Dominica Geothermal
Development Company Limited
Powering a New Generation...

Bid Clarification Request (In accordance with ITB 7.1)

Reference Number:
RZ042100-PGG-COM-0046

Subject: Bid Clarification 0046 – Reinjection pipeline alignment

Modifications to Brine Reinjection Pipeline and Site Boundary (IP /020 - IP /040)
12 September 2019

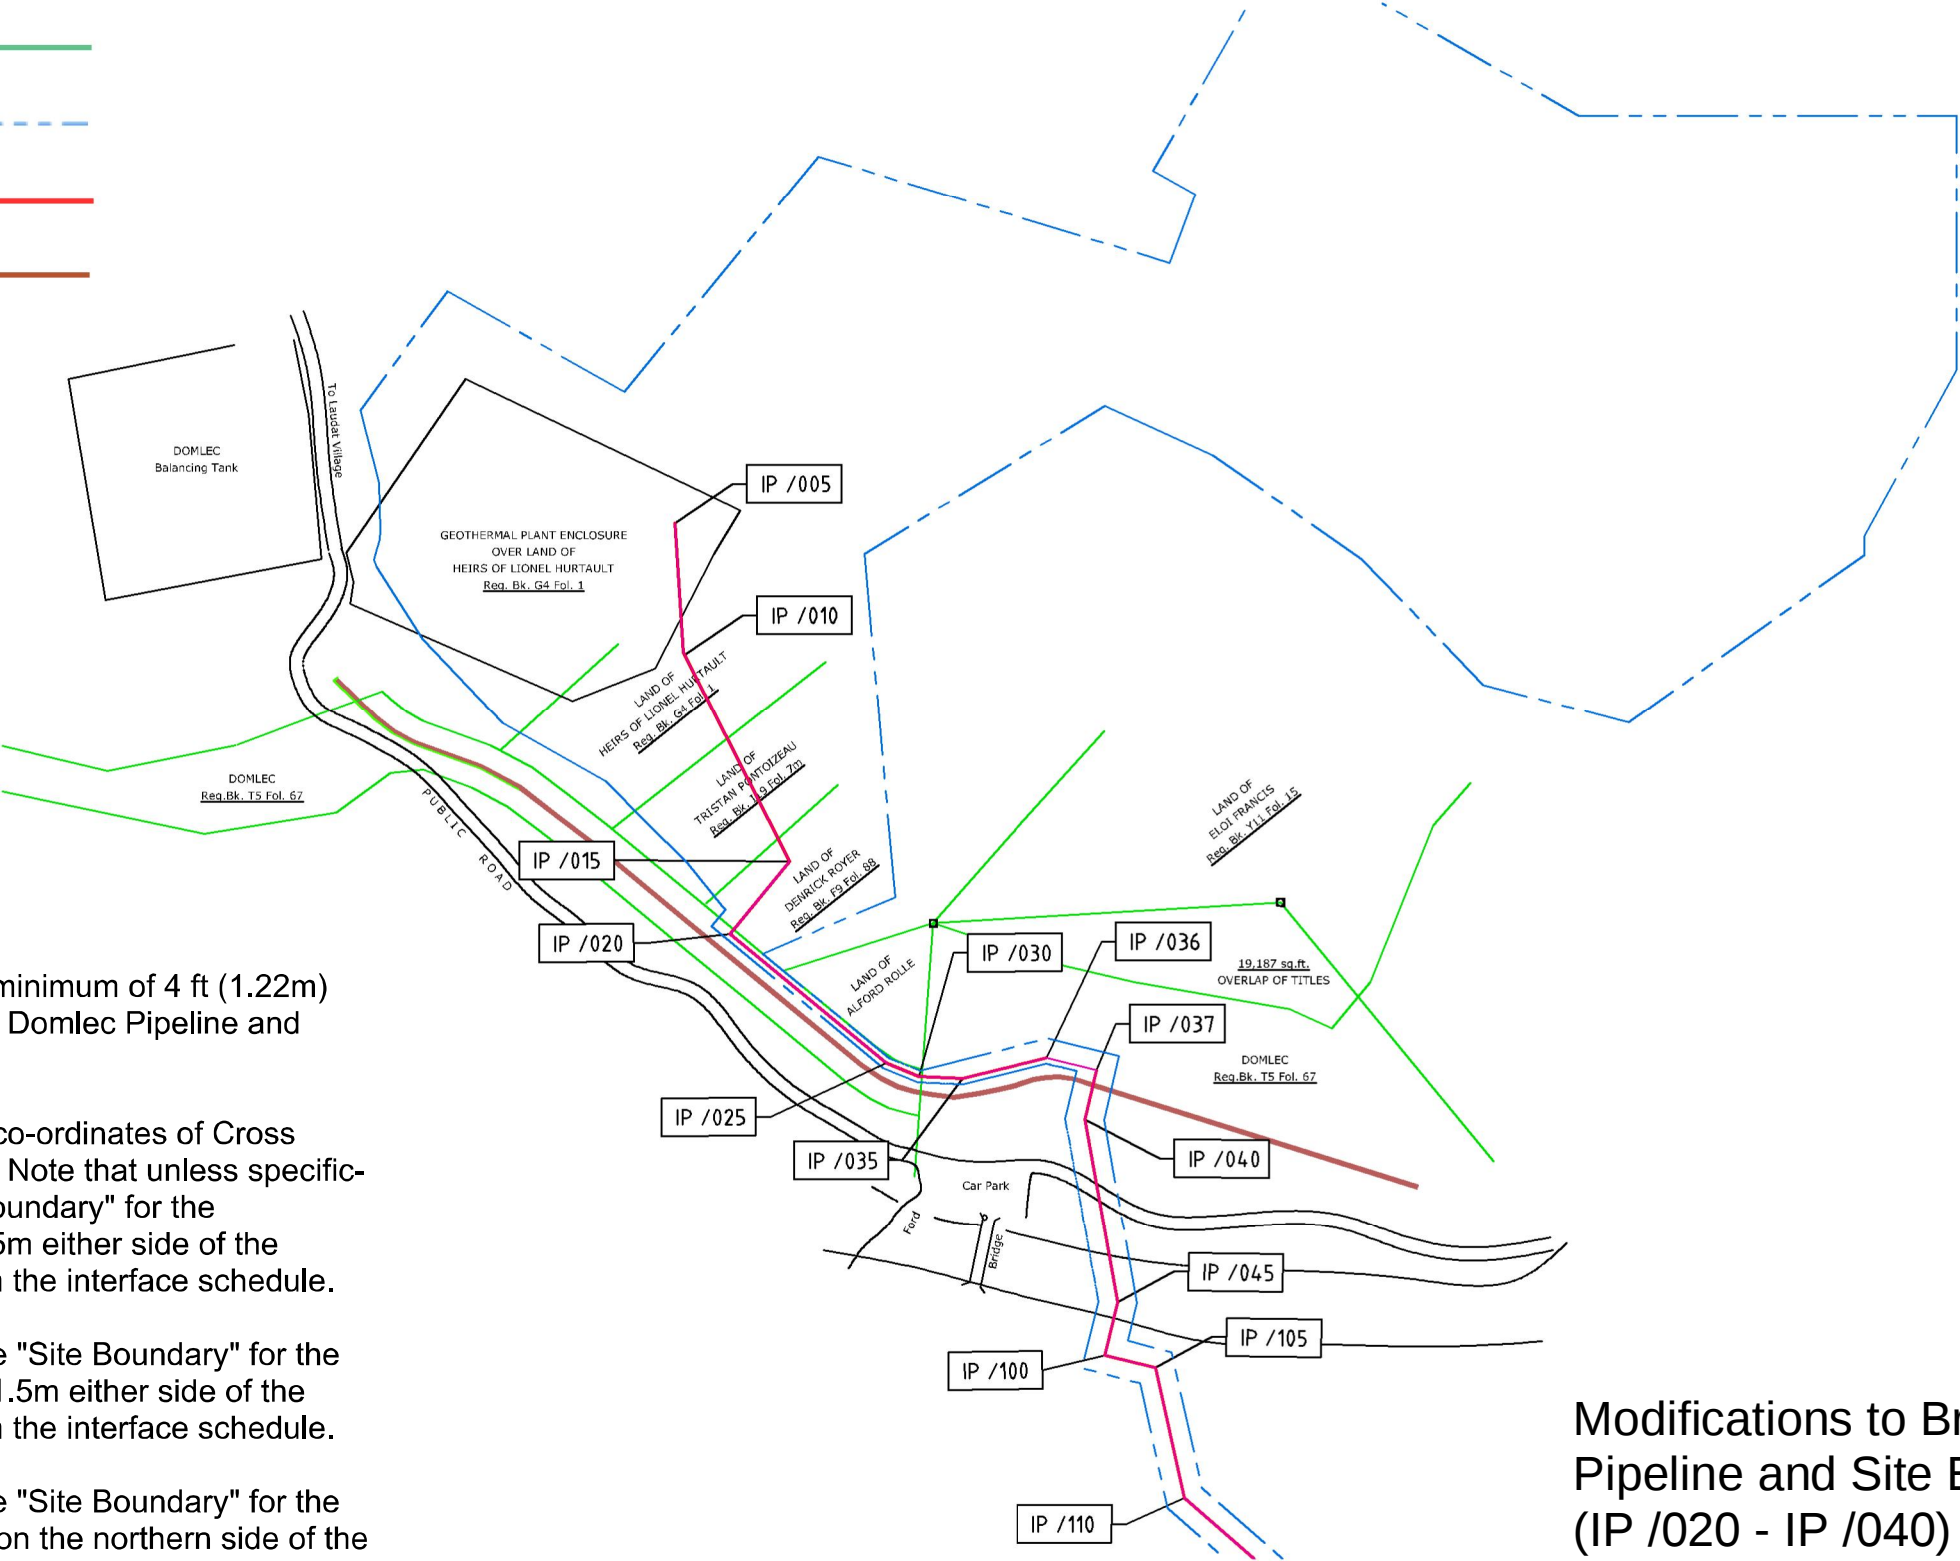
Clarification relating to small section of the reinjection pipeline alignment.

The Pipeline between nodes IP /020 and IP /040 has been rerouted as per the attached sketch, RZ042100-ME-SKT-001. This is to provide clarification of previous IP locations / drawing potentially conflicting with requirements outlined in Specification Section 10.12.2.

The following co-ordinates in the interface schedule are to be revised as noted below.:

IP /20	1695470277	679522189
IP /25	1695436213	679563549
IP /30	1695432702	679572158
IP /35	1695432161	679583646
IP /36	1695437602	679606105
IP /37	1695434483	679619259

To clarify further, delete the Site Boundary Nodes PT 7-1, PT 7-2, PT 7-3 and PT 7-4 from the interface schedule. The pipeline alignment in this area is now defined as an offset relative to the Centre Line (CL) of the brine line, as noted in the attached sketch.

1. Between IP /020 and IP /040 a minimum of 4 ft (1.22m) clear space is required between Domlec Pipeline and Brine Reinjection line.
2. Refer to Interface Schedule for co-ordinates of Cross Country line and Site Boundary. Note that unless specifically noted otherwise the "Site Boundary" for the Reinjection line is limited to +/- 5m either side of the pipeline centreline, as defined in the interface schedule.
3. Between IP /020 and IP /030 the "Site Boundary" for the Reinjection line is limited to +/- 1.5m either side of the pipeline centreline, as defined in the interface schedule.
4. Between IP /030 and IP /037 the "Site Boundary" for the Reinjection line is limited to 5m on the northern side of the pipeline centreline, and 1.5m on the southern side of the pipeline centreline, as defined in the interface schedule.
